QUALITY ASSURANCE -- NON-CONFORMANCE REPORT

Location: Changxing Island, Shanghai, China**Report No:** NCR-000904**Prime Contractor:** American Bridge/Fluor Enterprises, a JV**Date:** 23-Nov-2010**Submitting Contractor:** Zhenhua Port Machinery Company, Ltd (ZPMC), Changxing Island**NCR #:** ZPMC-0866**Type of problem:**

Reference Description: New Weld Procedure Not Being Followed (Rager/McQuaid)**Description of Non-Conformance:**

Dear: Mr. Charles Kanapicki
Job Name: SAS Superstructure

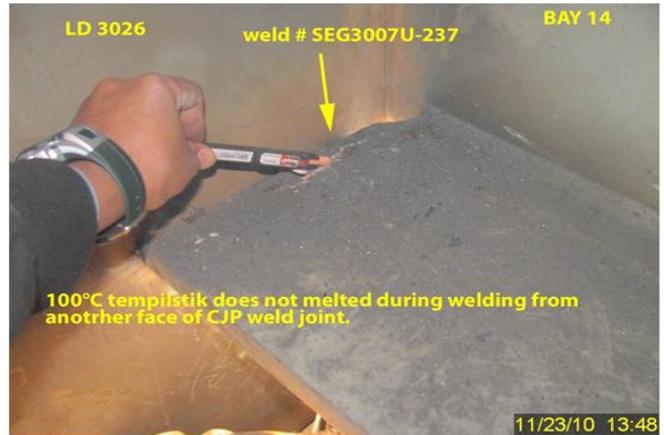
ISSUE 5B:

The weld is identified as SEG3007K-035.

The welding process used was FCAW.

The weld is a CJP joining LD 3025 to FB 3123 at PP 119+1500.

The thickness of the part observed to be 25mm X 20mm.

The weld is not SPCM

Component is located in Bay 14.

This proposed resolution is acceptable. The documentation received is sufficient and the Department concurs that Non-Conformance ZPMC-0866 is closed.
